BID ADDENDUM #2

Nanuet Union Free School District
103 Church Street
Nanuet, NY 10954

Nanuet Bond Projects Phase 5

Date: January 30, 2025

SHEET NUMBER: BM-A121

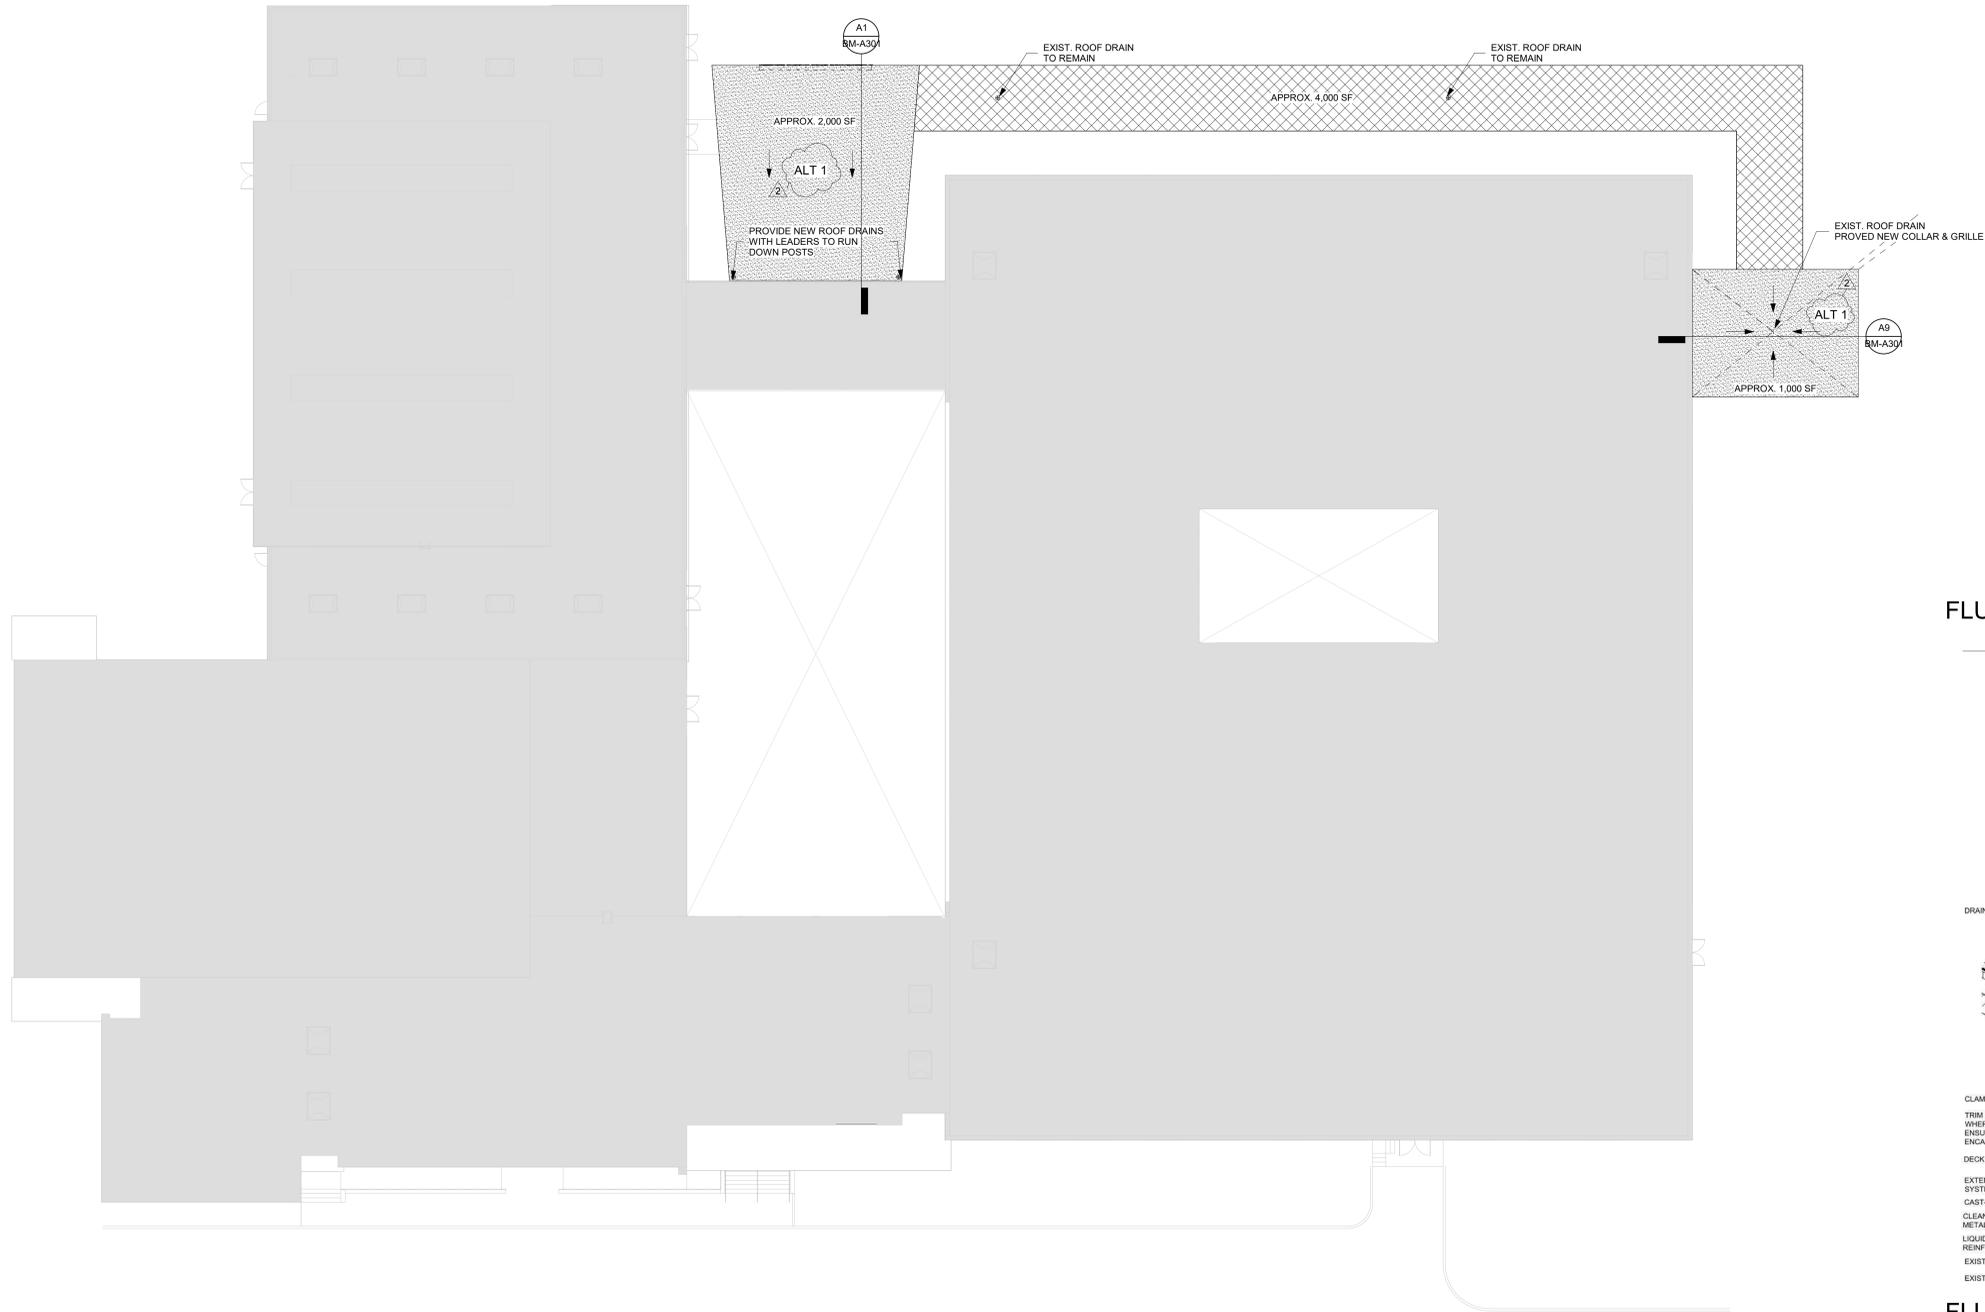
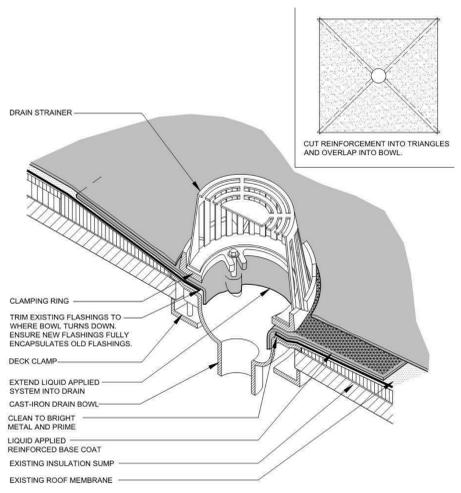
6. Sheet BM-A121: OVERALL CANOPY ROOF PLAN

SHEET NAME:
OVERALL CANOPY ROOF
PLAN - ALTERNATE 2

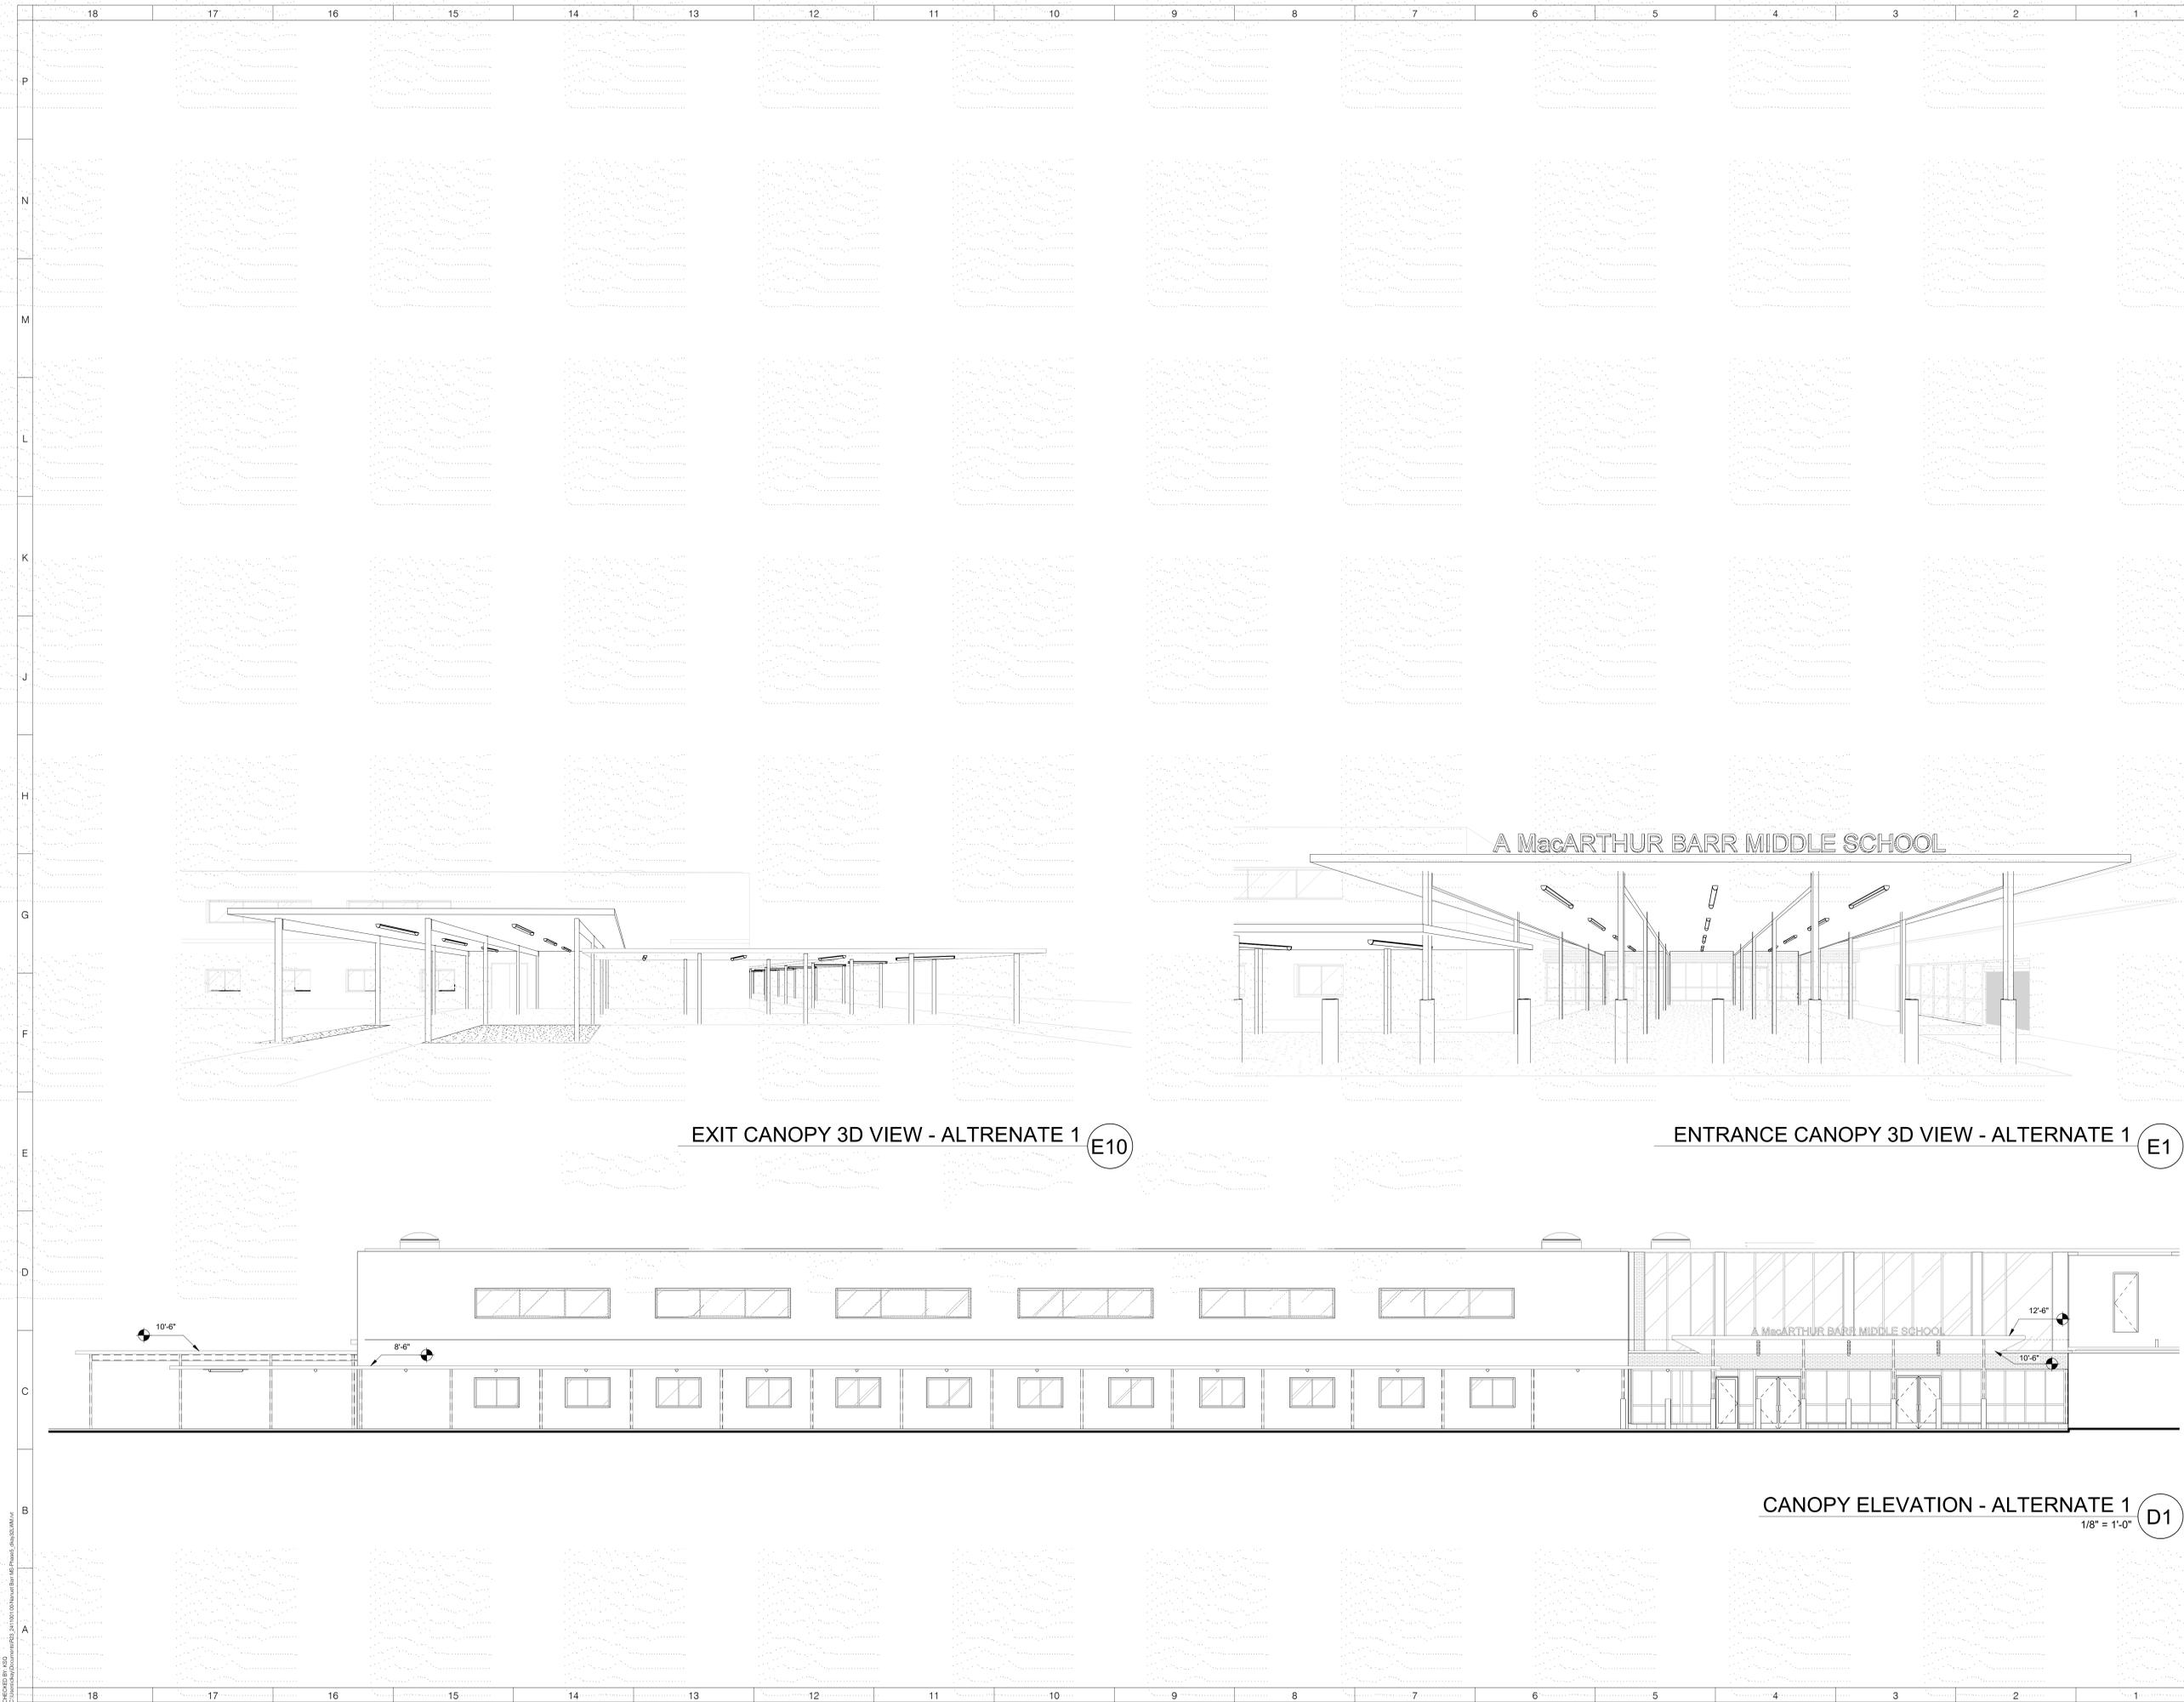
7. Sheet BM-A121.2: OVERALL CANOPY ROOF PLAN – ALTERNATE 2

A. Added sheet to reflect Alternate 2 notes for new liquid applied roof coating to be installed existing canopies roofs at the main entrance and at the east side of the building to remain

SHEET NUMBER:
HE-E401

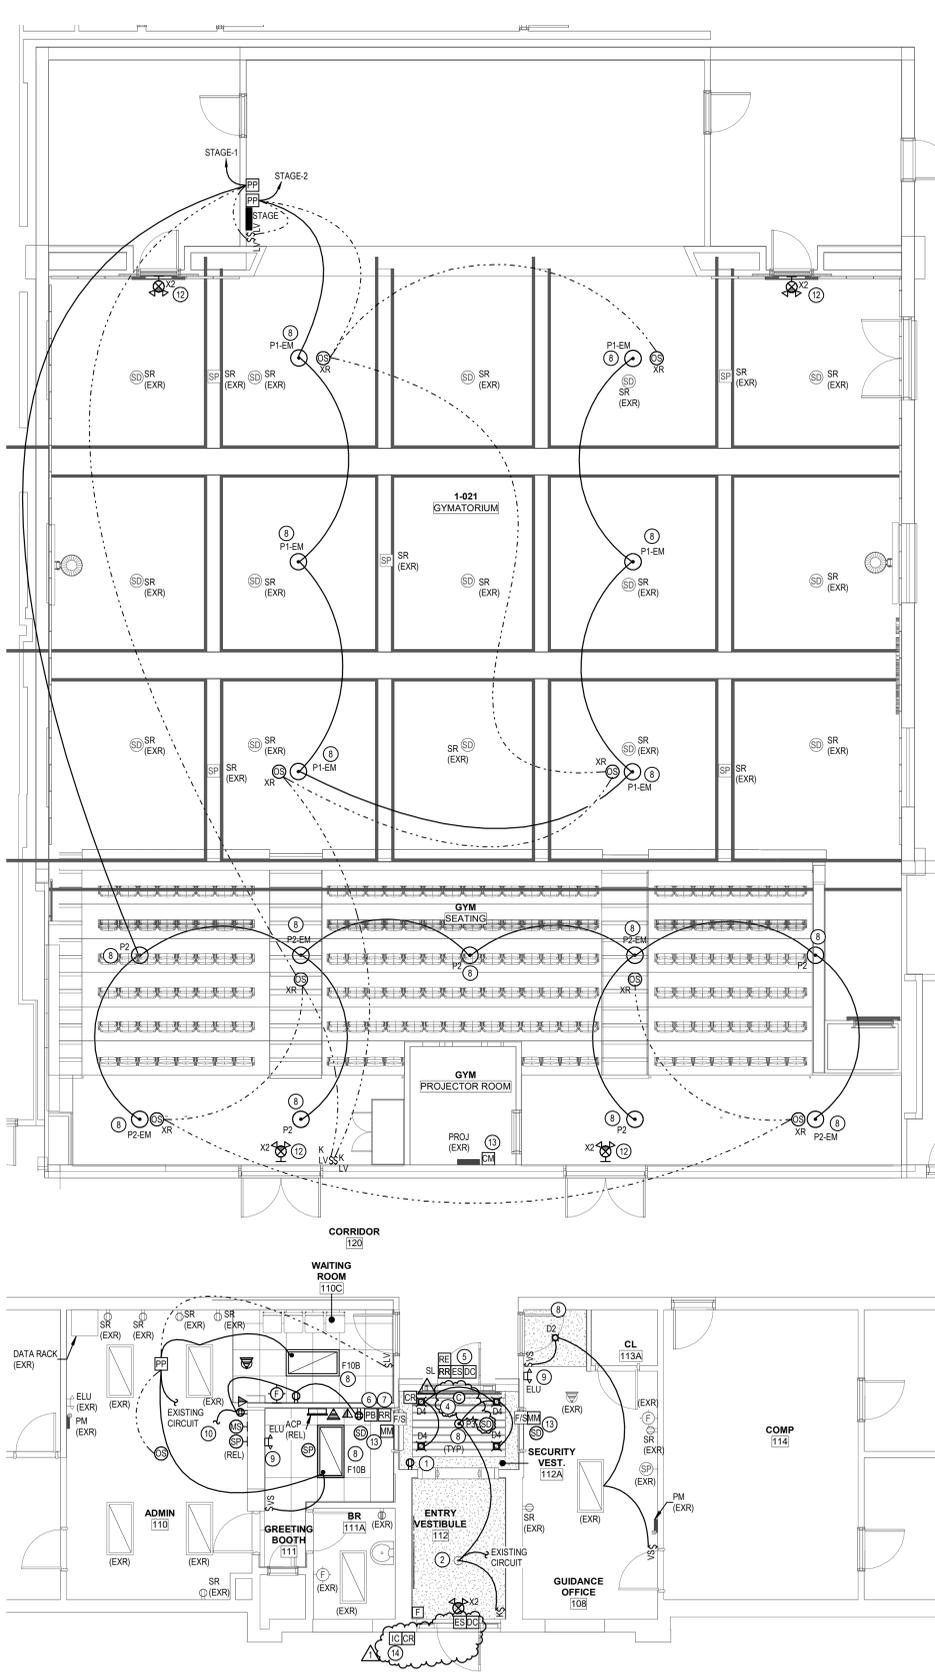
- 1. **Sheet HE-E401: ENLARGED ELECTRICAL PLAN**
 - a. Updated to reflect video intercom door closer locations, note 14.
- 2. **Sheet MB-E101: OVERALL ELECTRICAL PLAN**
 - a. updated ceiling at breakroom and electrical closet updates.
- 3. **Sheet MB-E601: PANEL AND FIXTURE SCHEDULE**
 - a. Updates based off new fixtures on MB-E101.
- 4. **Sheet ME-E101: OVERALL ELECTRICAL PLAN**
 - a. Updates at Meeting rooms A-6 and A-7.
